OCONEE NUCLEAR STATION

TECHNICAL SPECIFICATIONS

TECHNICAL JUSTIFICATION

The proposed revision to the Technical Specifications described in Attachment 1 changes the surveillance requirements for valves LPSW-4 and LPSW-5 in Technical Specification 4.5.1.1.2 (a) (2) and revises the bases. In addition, editorial clarifications to Technical Specification 4.5.1.1.2 are proposed.

FIGURE 1 - LP/LPSW SYSTEMS

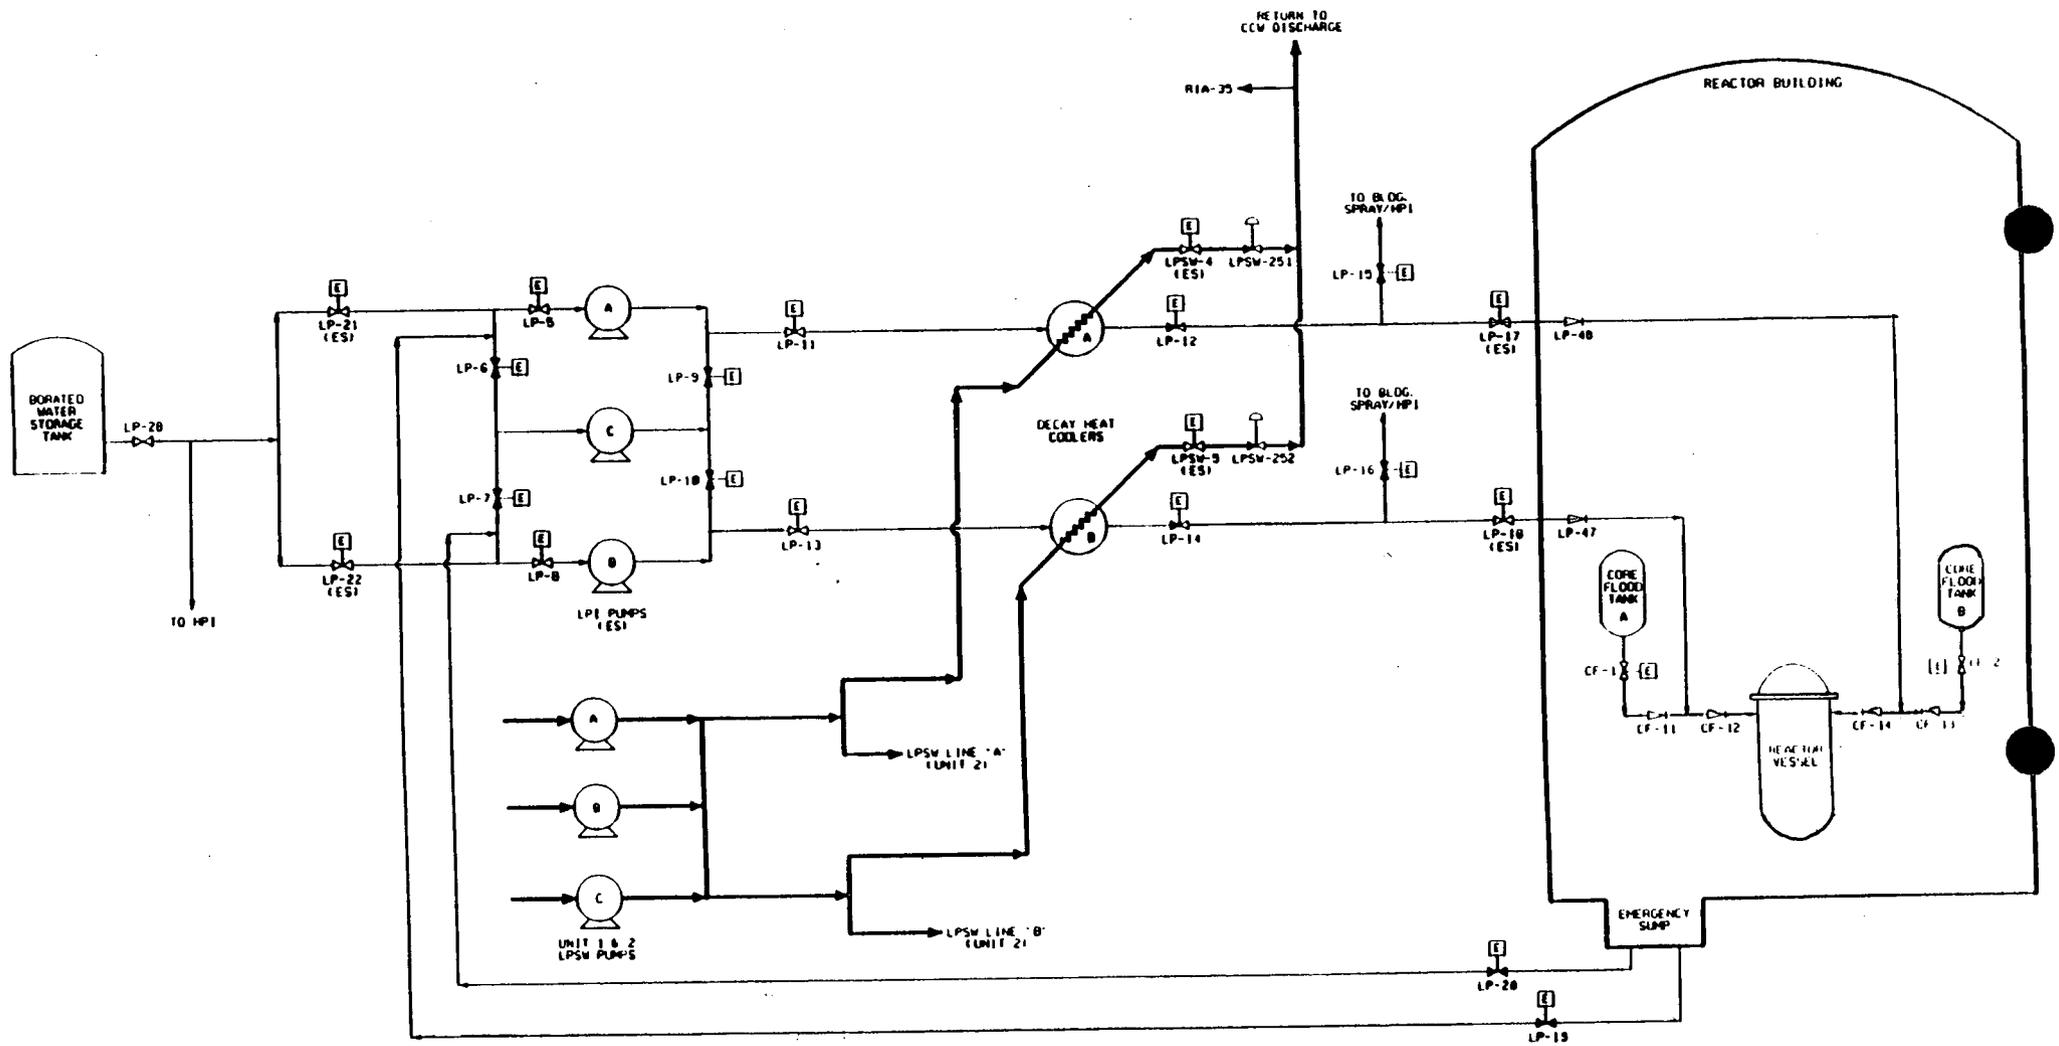
To resolve the NPSH issues, Duke proposes to remove the ES signal that automatically opens valves LPSW-4 and LPSW-5. After establishing RBES recirculation mode, operators would isolate flow to the LPSW non-essential header and throttle open LPSW-4 and LPSW-5 from the control room. This will maintain LPSW flow demand low enough so that the NPSHa remains greater than NPSHr.

Removing the ES signal from valves LPSW-4 and LPSW-5 requires a change to Technical Specification 4.5.1.1.2 (a) (2). This Technical Specification requires a functional verification of the ES function of valves LPSW-4 and LPSW-5 on a refueling outage frequency. Under the proposed change, the reference to ES will be changed so that it applies to the LPSW pumps but not to LPSW-4 and LPSW-5. The capability of the operators to open LPSW-4 and LPSW-5 from the control room will be verified under this revised surveillance requirement.

FIGURE 2 - NON-ESSENTIAL LPSW LOADS

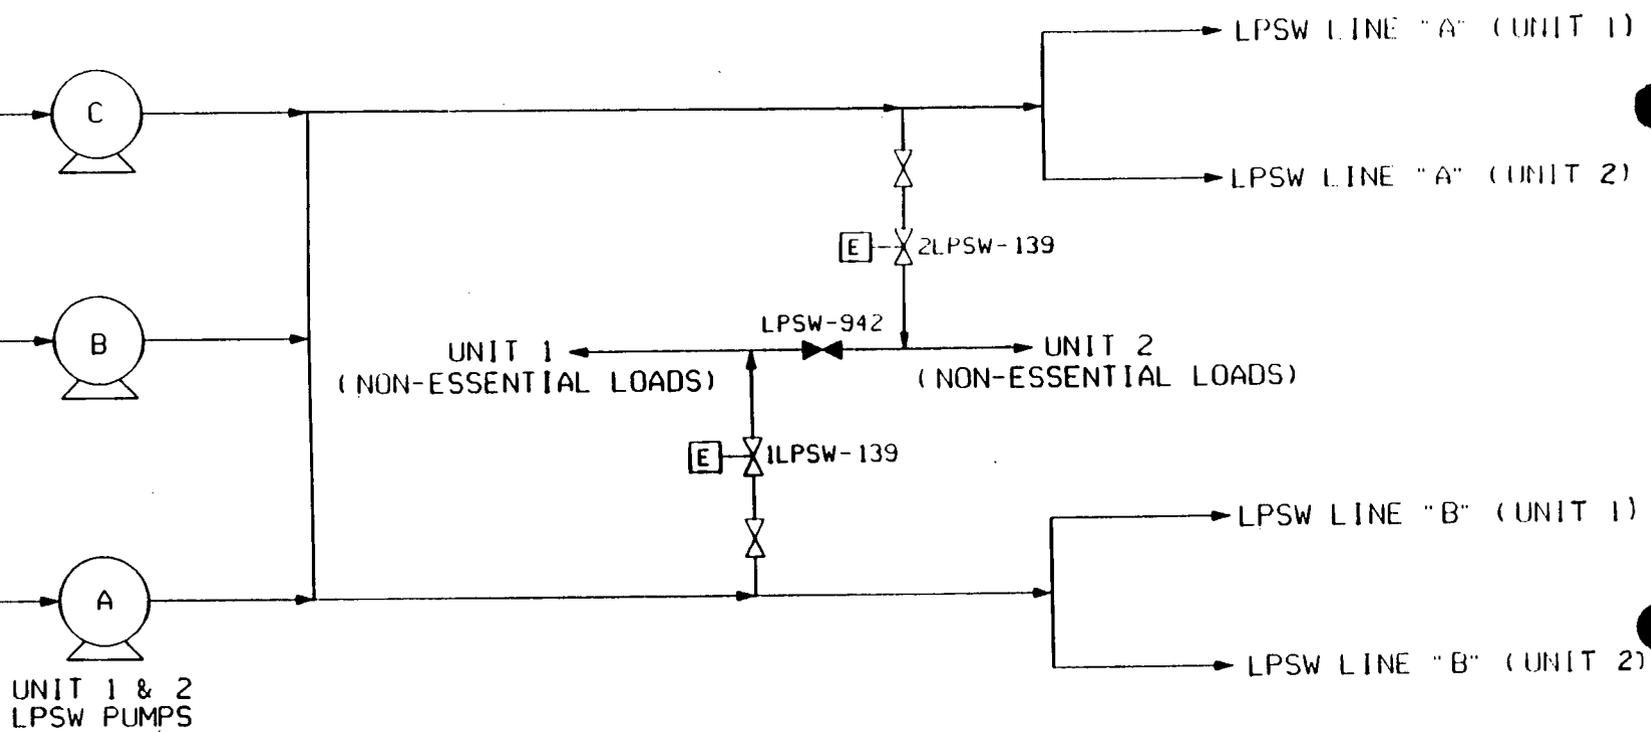
A review of the operator burden for opening LPSW-4 and LPSW-5 was performed. During the first 30 minutes after a LOCA/LOOP, actions performed by the operators would not be affected by the proposed change. During this period, the operators must verify proper operation of all ES equipment. Also, operators monitor BWST level and begin switchover to RBES recirculation at the appropriate level in the BWST. After completion of the switchover to RBES recirculation, operators would be required to isolate the LPSW non-essential header. Isolation of the non-essential header will require closing one valve, either 1LPSW-139 (Unit 1), 2LPSW-139 (Unit 2), or 3LPSW-45 (Unit 3). After completion of the ECCW upgrade project, controls for these valves will be located in the control room for their respective unit. In addition, valve 3LPSW-45 will be renumbered as 3LPSW-139 to be consistent with the other units' valve numbers. See Figure 2 for the planned configuration for the Unit 1 and 2 LPSW non-essential header.
